SUBJECT: VOGTLE ELECTRIC GENERATING PLANT, UNITS 1 AND 2 – STAFF  
ASSESSMENT OF RESPONSE TO 10 CFR 50.54(f) INFORMATION REQUEST  
– FLOOD-CAUSING MECHANISM REEVALUATION (TAC NOS. MF1117 AND  
MF1118)

STAFF ASSESSMENT BY THE OFFICE OF NUCLEAR REACTOR REGULATION

RELATED TO FLOODING HAZARD REEVALUATION REPORT

VOGTLE ELECTRIC GENERATING PLANT, UNITS 1 AND 2

Figure 3.2-1. Drainage of the VEGP Units 1 and 2 powerblock area represented by a level-pool scheme (taken from the RAI response (Pierce, 2014a).

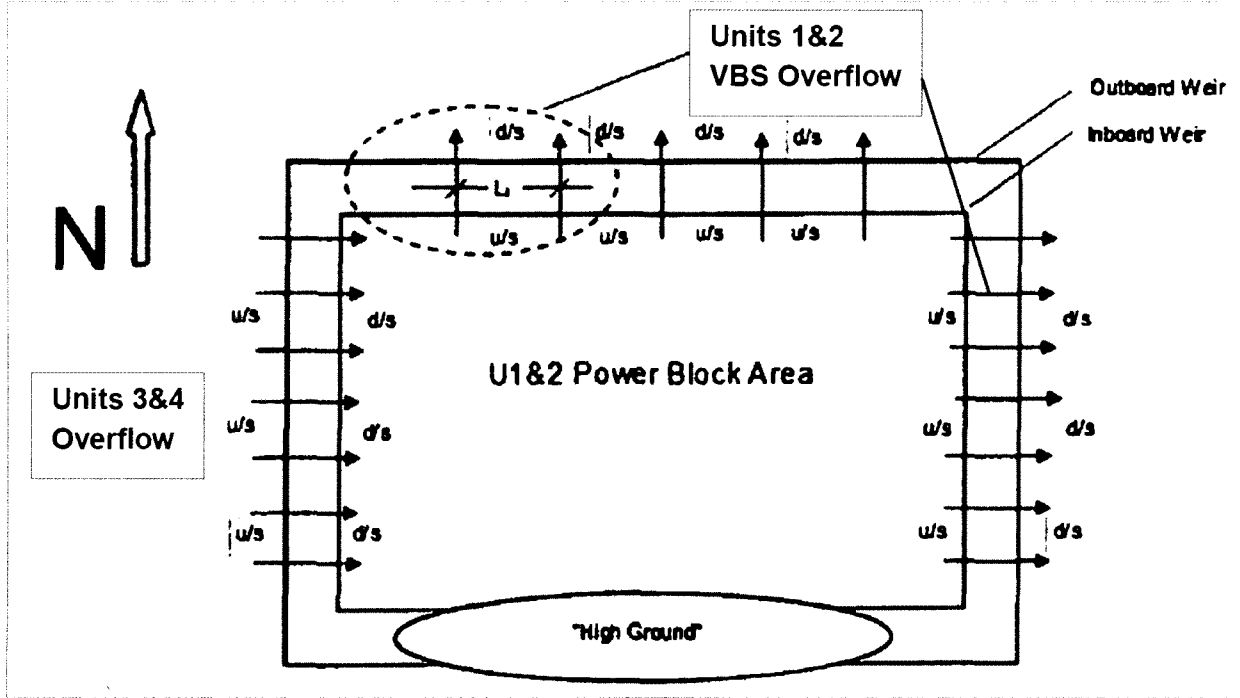
FHRR Section 2.1 discusses a HEC-HMS modeling approach to estimate the new design-basis LIP flood hazard within the area encircled by the VEGP, Units 1 and 2 VBS as shown on Figure 3.2-1. The same modeling approach was used for the reevaluation with changing PMP values. The licensee initially used a 6-hour duration PMP scenario as described in the FHRR. The licensee later submitted the result of the maximum LIP flood elevations for three additional PMP durations (e.g., 12-, 24-, and 48-hour) (Pierce, 2014b). This additional information indicates that the predicted maximum water-surface elevations and outflow rates for different PMP durations are nearly identical as they used bounding basin runoffs, but times to peak are different.

As a result of the review, the staff found that the entire VEGP, Units 1 and 2 powerblock area is modeled by a single subbasin as a reservoir. An external model was used to determine a state-discharge relation within this subbasin. The licensee assumed that the subbasin is represented by a level-pool conceptual model. The level-pool model is a direct representation of the principle of the conservation of mass which states the change in storage is equal to the inflow less the outflow. One of the major input variables on the model is runoff created by a PMP scenario within the powerblock area. The licensee applied a level-pool assumption for water that flows within the subbasin and collects behind the VBS.

The staff reviewed the licensee-provided onsite topography map (Pierce, 2014a). The staff noted that the some elevations for the VEGP, Units 1 and 2 area, especially in the central powerblock area, are higher than the nominal plant grade. The area near the Reactor Buildings and Turbine Buildings, which are safety-related structures, are well above elevation 220 ft (67 m). The staff noted that this critical building area would be inundated significantly by accumulated runoffs from nearby building roofs and the LIP flood levels on this critical area would be much higher than the licensee's estimated elevation of 219.3 ft (66.8 m), which is lower than the land surface elevations. The staff found that one uniform water-surface level estimated on the top of the VBS system cannot represent the varying flood elevations at all locations within the VEGP, Units 1 and 2 area, especially at the center of the powerblock area which is where many safety-related buildings are located.
